## CITY OF ALLENTOWN

**R110 – 2020**

**Certificates of Appropriateness for work in the Historic Districts: 1619 W Turner Street; 443 N 9th Street; 1142 W Linden Street; 248 N 9th Street; 817 W Gordon Street.**

**HISTORIC ARCHITECTURAL REVIEW BOARD  
CITY OF ALLENTOWN, PENNSYLVANIA  
August 31, 2020**

**Address:** 1619 W Turner Street --

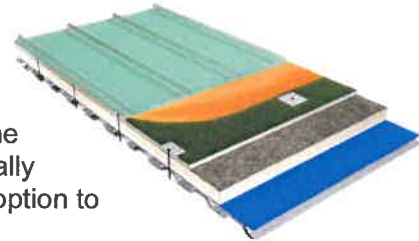
**Evaluation, effect on historic district, recommendations:** Standard EPDM membrane roofing is potentially historically appropriate but another more appropriate option is Sarnafil membrane roofing. This PVC membrane roofing is available in several colors. The Copper Brown color is a brownish red that would be similar to the existing painted roofing. The roofing is used to simulate metal roofing (or without ribs) and should be close to the cost of EPDM.

**Discussion:** There was a brief discussion of the proposed roof replacement. The Consultant and the HARB commended the owner for his care and stewardship of the property. The HARB agreed that the Consultants suggested alternative to the proposed EPDM roofing would be ideal for the property, but also thought the EPDM roofing would be historically appropriate. It was suggested to give the property owner the option to use either material.

1. The proposal to replace red tin porch roof with black rubber roofing material at 1619 W Turner Street was represented by Jay Robinson.
2. The existing deteriorated metal roof may be replaced with either EPDM as proposed or Sarnafil PVC membrane as suggested by the HARB Consultant.
3. The Sarnafil membrane, if used, would be the Copper Brown color.
